**PLANNED UNIT DEVELOPMENT
& SUBDIVISION STAFF REPORT****Date: June 5, 2008****DEVELOPMENT NAME**

Rochester Place Subdivision

Planned Unit Development Approval to allow a gated private street single-family residential subdivision, and Subdivision Approval to create 10 lots.

DETAIL SITE PLAN

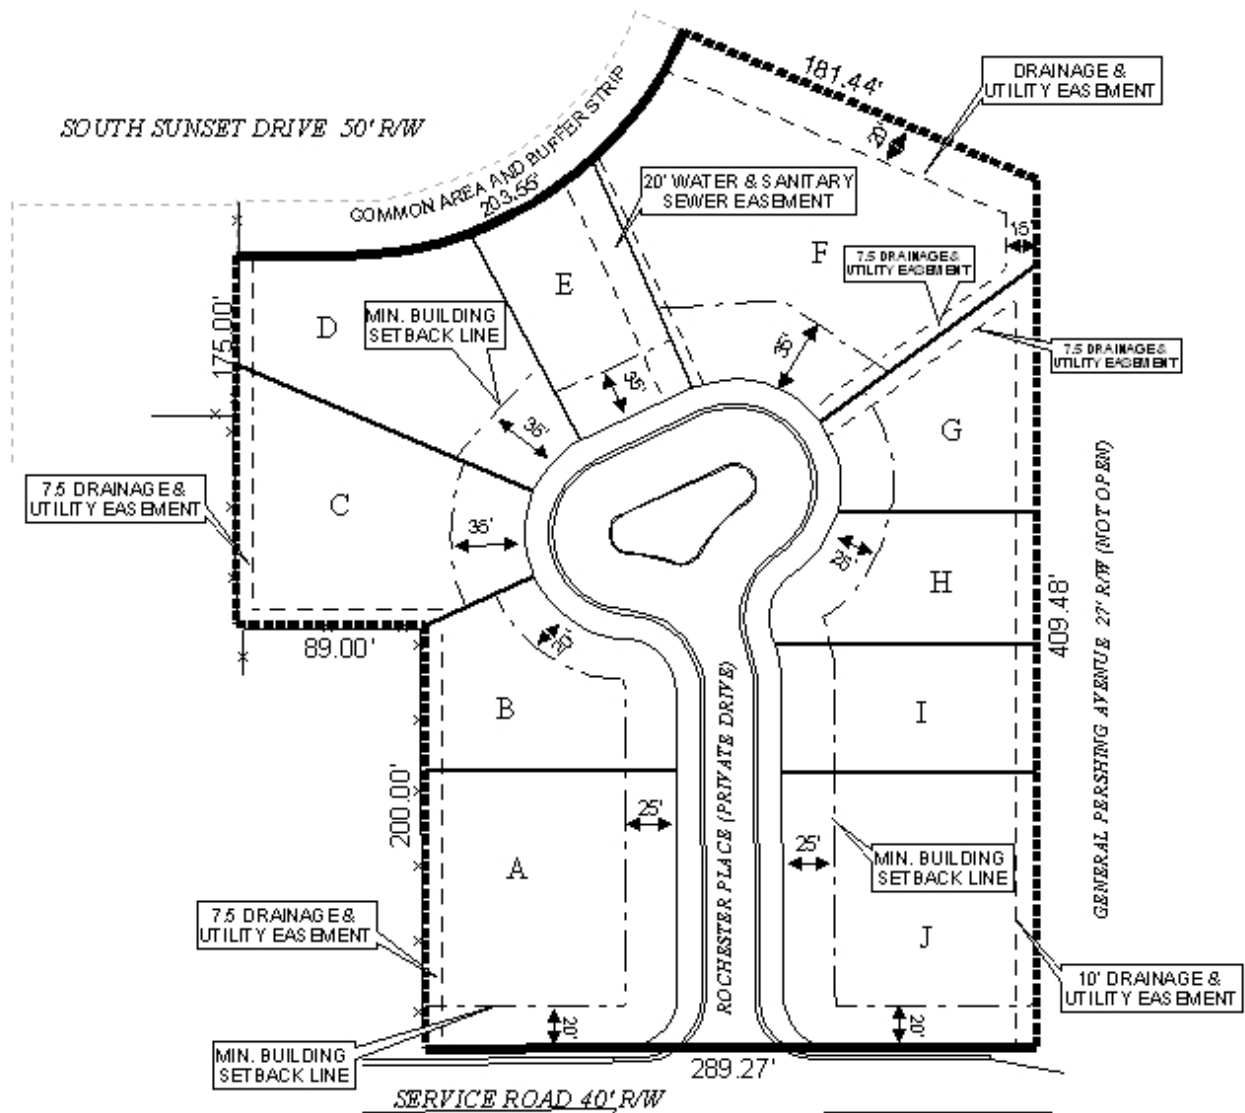
Property to be developed in compliance with state and local laws that pertain to tree preservation and protection on both city and private properties (State Act 61-929 and City Code Chapters 57 and 64). Preservation status to be given to the 53" live oak near the lot line between Lots C and D (Any work on or under this tree is to be permitted and coordinated with Urban Forestry, removal to be permitted only in the case of disease or impending danger).

While approval of the applications now before the Commission should have little difficulty being approved, there is one issue that should be taken into consideration – Sidewalks. While sidewalks are not automatically required along private streets, there are properties within this subdivision that have constructed sidewalks since they were on a public street (or have shown them on the plans approved for construction). If sidewalks are existing adjacent to any of these properties, then it would seem illogical for them not to be provided adjacent to all properties within the subdivision.

- 4) provision of sidewalks along ALL street frontages (public or private);
- 5) placement of a note on the final plat stating that if the gate ceases to operate, the road must be dedicated to the City;
- 6) preservation of the 53" Oak (any work on or under this tree is to be permitted and coordinated with Urban Forestry; removal to be permitted only in the case of disease or impending danger), as well as, protection status for any existing trees that are located within the existing Right-of-Way.
- 7) placement of a note on the final plat stating that the site is denied direct access to Sunset Drive South.
